UNITED STATES OF AMERICA
NUCLEAR REGULATORY COMMISSION
OFFICE OF THE SECRETARY
ATOMIC SAFETY AND LICENSING BOARD

In the Matter of)	
)	Docket No. 50-0219-LR
AMERGEN ENERGY COMPANY, LLC)	
)	ASLB No. 06-844-01-LR
(License Renewal for the Oyster Creek Nuclear Generating Station))	June 23, 2006

PETITION TO ADD A NEW CONTENTION

Subject: Discussion of Corrosion Monitoring Methodologies
At Oyster Creek Nuclear Plant Dry Well

Figure 1

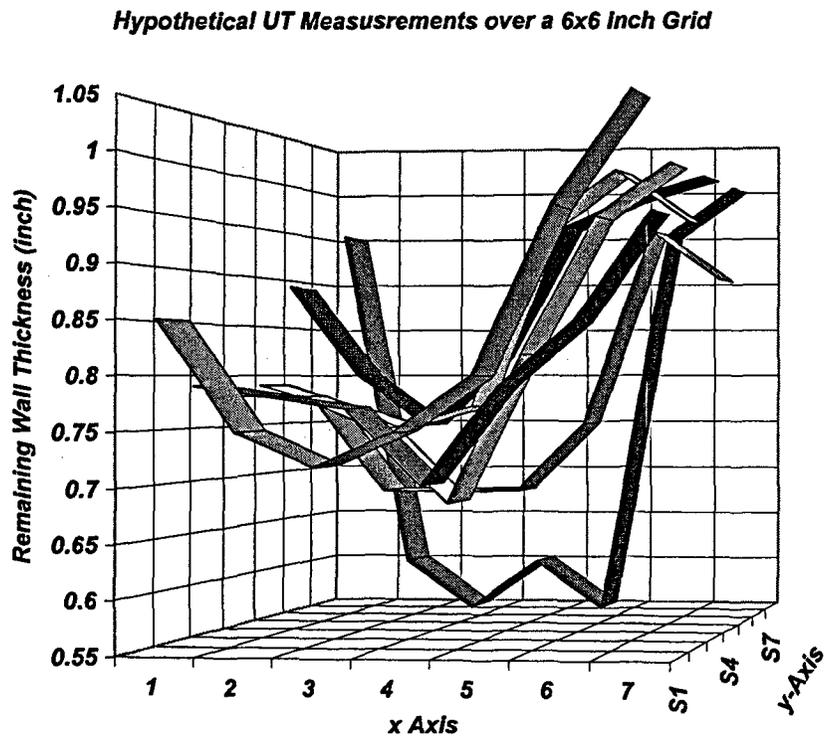
Since the actual original UT measurements were not available for a detailed statistical analysis, a hypothetical 6x6 inch grid was constructed to illustrate a point to be made here. Figure 1 shows hypothetical UT measurements in a 6x6 grid with 1 inch spacings. The average wall thickness over the grid is 0.81 inches. However, as is often the case in real life, a corrosion trough is depicted parallel to the y-axis with an average depth of 0.68 inches and a maximum depth of 0.55 to 0.60 inches. While this example is not a real life observation, it nevertheless illustrates how averages can be misleading. In this particular case, the corrosion trough exceeds the grid, and one could not tell whether corrosion would become more severe or less severe beyond the boundaries of the grid. Similarly, when Amergen talks about "isolated minimum thickness measurements", one does not know where these were recorded and whether there were others, which exceeded the average wall loss, but

Figure 2

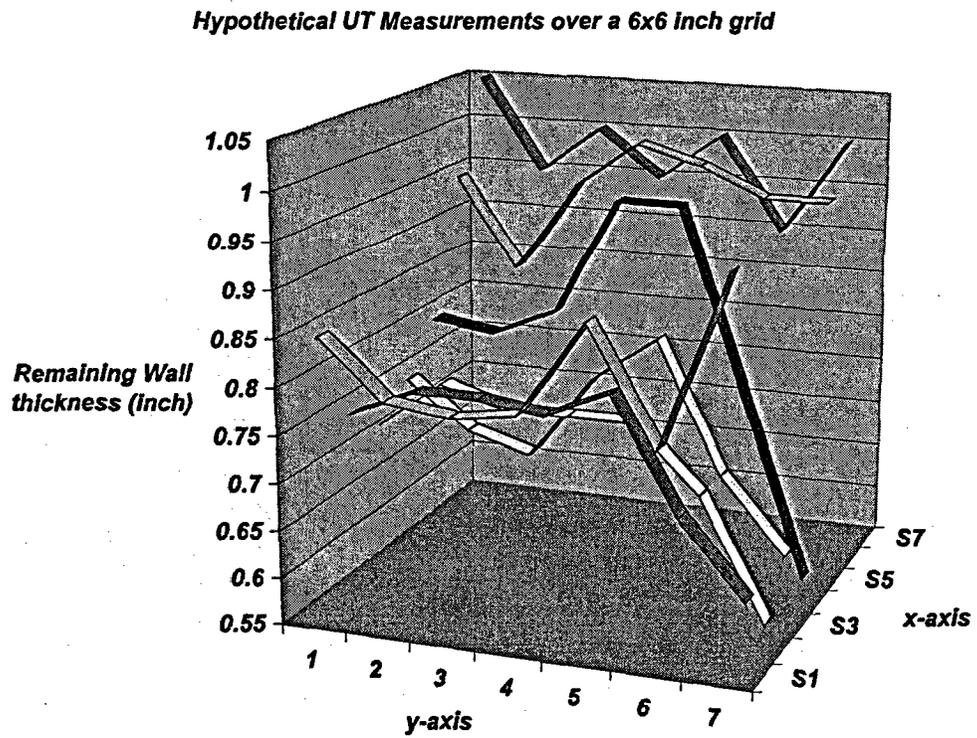
may have been above the quoted minimum wall thickness. When the same data shown in Figure 1 are plotted from a different perspective (Figure 2), conclusions may be different, but again it appears that there may be an extensive corrosion phenomenon on one side of the grid.

c. Figure 6

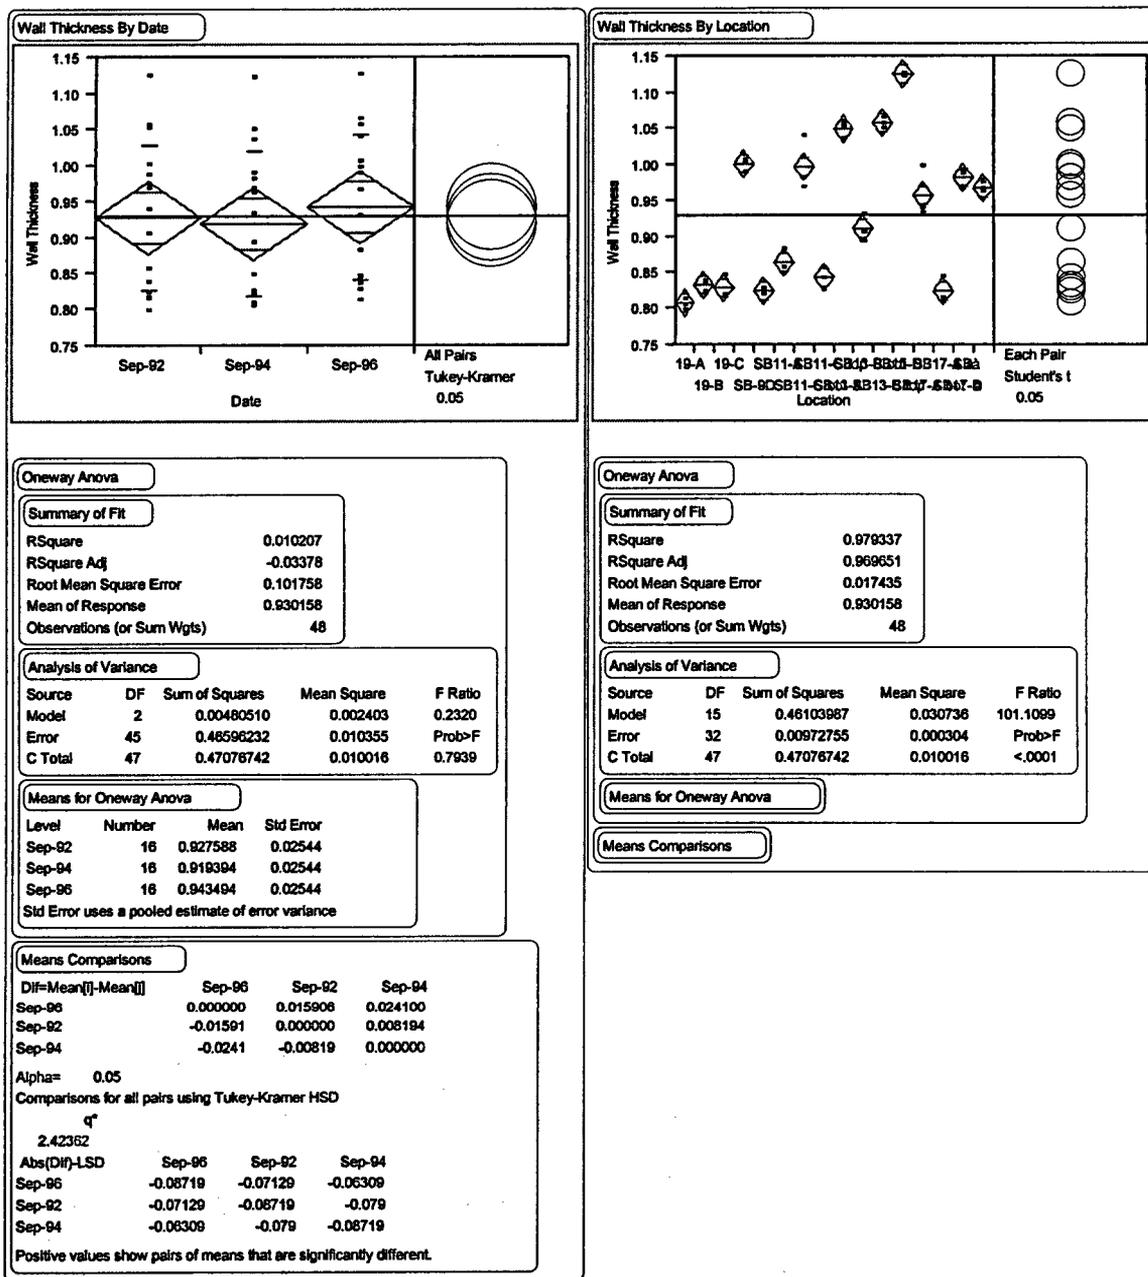
higher than the previous two. This is shown in Figure 5. However, a statistical Analysis of Variance (ANOVA), Figure 6, shows that there is no significance to these variations from date to date if the data are amalgamated. However, the differences from location to location are indeed very significant. On the basis of these data AmerGen concluded that the corrosion was arrested following the application of the epoxy coating. It is probably correct that *on average* the corrosion was significantly slowed or even arrested during the four years covered by the measurements. Whether the extreme corrosion rates were also similarly affected remains an open question. Nevertheless, it would be logical to expect that corrosion slowed down following the application of the coating, at least for a period of time. It is, however, stretching credulity to assume that such protection would last in excess of the stated lifetime of the coating, which was specified as 8 to 10 years.

Figure 7

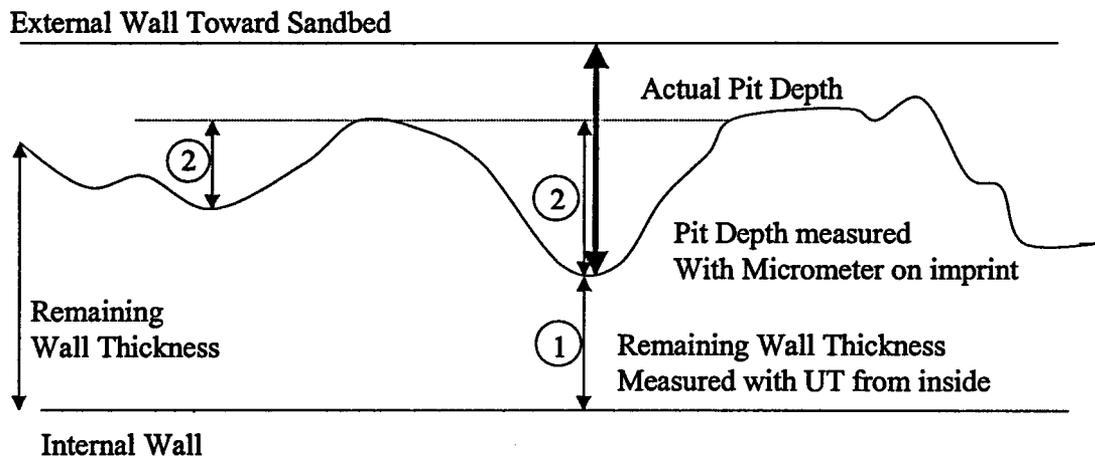
Figure 7 is a schematic of what I understand was done to arrive at a representative remaining wall thickness in the former sandbed region in order to subsequently perform GE type vessel integrity calculations. First: UT measurements were taken from the inside as described earlier. Second: an imprint (or cast) was taken from the

outside in order to characterize the roughness of the corroded surface in addition to the UT measurements. The roughness is also characterized as "dimples". The depth of the dimples was measured from the imprint by means of a micrometer. Thus, Figure 7 shows the UT measurement (1) from the inside, which characterizes the remaining wall thickness. Second, the dimple depths were measured (repeatedly) and averaged (2). This average was added to each UT measurement. Third, a characteristic average dimple depth was determined and used as a global average to be used in all areas where imprints were not available, or where such were performed in a reduced fashion. The reason for this procedure is not entirely clear, other than hopefully arriving at a representative average, which could be the basis for the integrity calculations.

As can be seen from Figure 7, the first location: if the average dimple depth is added to the UT remaining wall thickness, and then a global average dimple depth is being subtracted from the result, the actual pit depth may be reduced. In the second location the actual average pit depth may be increased by this procedure.

Figure 8

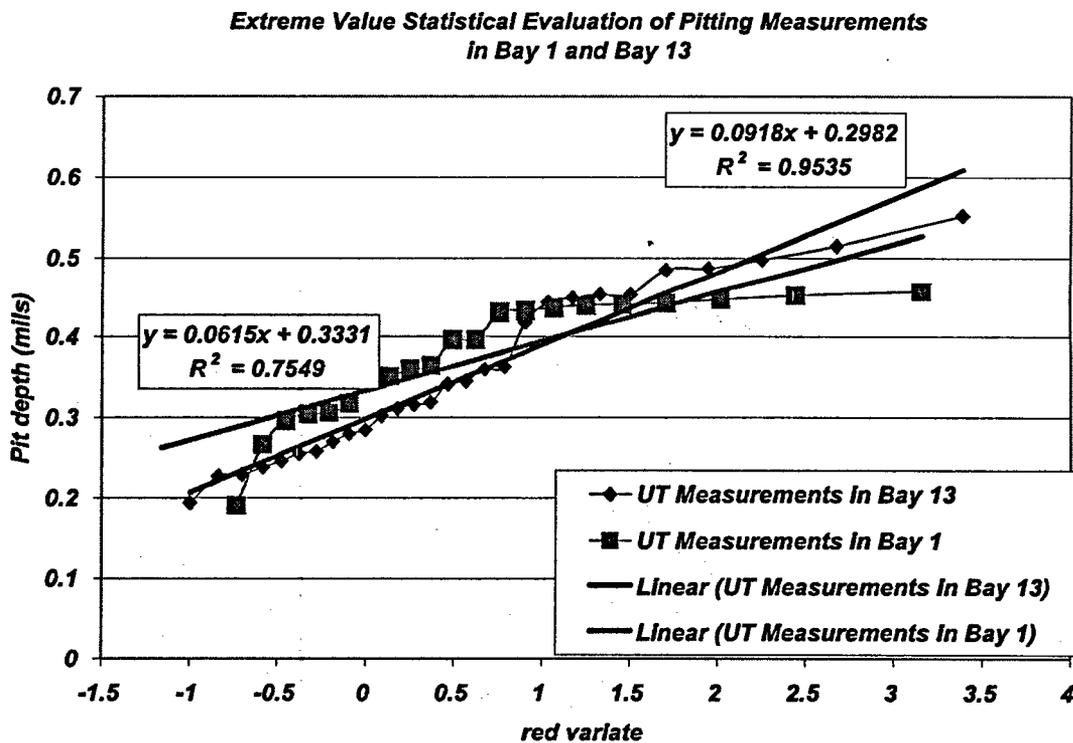
Figure 8 shows the extreme value statistical evaluation of the UT Measurements in Bays 1 and 13. It can be seen that worst case penetrations can be predicted to be of the order of 550 to 600 mils, or dangerously close to the criteria for the remaining local wall thickness of 490 mils. Hence, predictions of this nature, which in the case of Bay 13 are reasonably accurate, ($R^2 = 0.95$), are considerably less optimistic than those of GPU Nuclear.

Figure 9

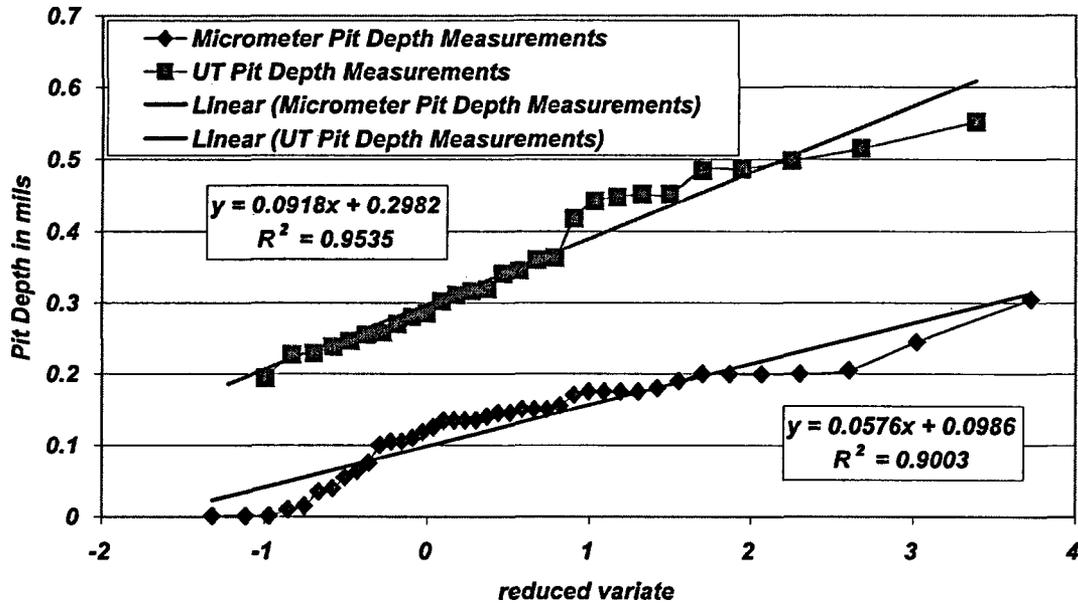
Figure 9 shows a comparison of the measurements in Bay 13 of the UT remaining wall thickness and the dimple depths. The correlations are reasonably good. The prediction for the most severe dimple depth is about 300 mils, or 50% larger than the average used by GPU Nuclear, and more in line with the use of 2 standard deviations.
